Comments on Accepted Changes

Allow Ltd ('Allow')

Deadline 3A – 1st Dec 2020

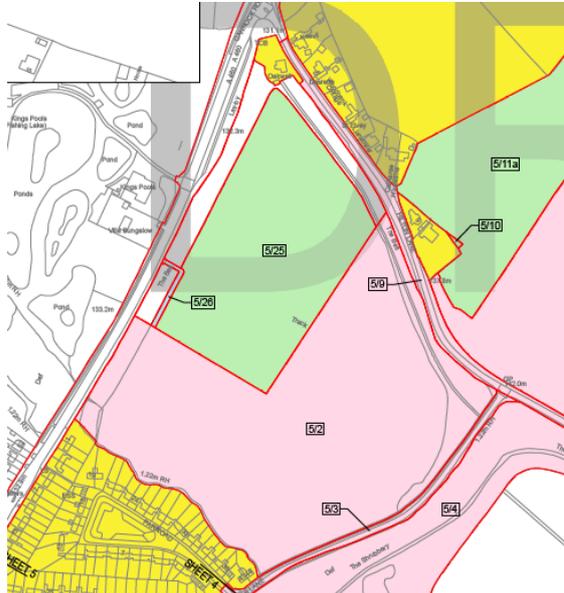
1.1. The removal of land to be acquired compulsorily from plot 4/20c and shown on drawing number HE514465 -GHX -LLO Z1_SW_PR_Z -DR-LR-1004 ('Dwg 1004') supports Allow's position that the extent of land required for ecological mitigation is excessive. An extract from Dwg 1004 is shown below. Allow's Ecologist, Aspect, identified that the Great Crested Newt assessment in the Applicant's Environmental Statement was excessive. It is noted that the removal of the triangular area from plot 4/20c has been removed because the Applicant has this year carried out more recent and accurate Great Crested Newt surveys resulting in less land to be acquired compulsorily for Great Crested Newt ponds. Allow's view remains that the extent of land currently required permanently from plot 4/20c is not necessary or proportionate and in event can be placed on land owned by Allow to the east of the proposed link road.

1.2. Allow's retained land within plot 4/20c shown coloured white within plot 4/20c on Dwg 1004 ('Allow's Retained Land Within Plot 4/20c') has no access. The Applicant seek permanent compulsory purchase powers in respect of all the land within plot 4/20c that abuts Allow's Retained Land Within Plot 4/20c. The consequence is that if the compulsory purchase powers are granted by the Examining Authority Allow will have no access to Allow's Retained Land Within Plot 4/20c. Allow ask that the Examining Authority modify plot 4.20c so that it provides suitable access along both Dark Lane and plots 4/20a and b.

1.3. No adequate reasons have been provided to explain why the land to the north of Allow's Retained Land Within Plot 4/20c that fronts Dark Lane is required compulsorily. There is no indication that this strip of land will provide ecological mitigation or the purpose for which the Applicant wishes to acquire this strip of land permanently using compulsory purchase powers. If it is the case that the Applicant wishes to upgrade existing fencing along Dark Lane

it is not necessary for such land to be acquired compulsorily. The environmental mitigation plans show 6 existing trees and a proposed new hedge along the boundary of Dark Lane. The Examining Authority should note that 5 of the 6 trees are located on Dark Lane and not within the strip of land in Allow's ownership the Applicant wishes to acquire compulsorily.
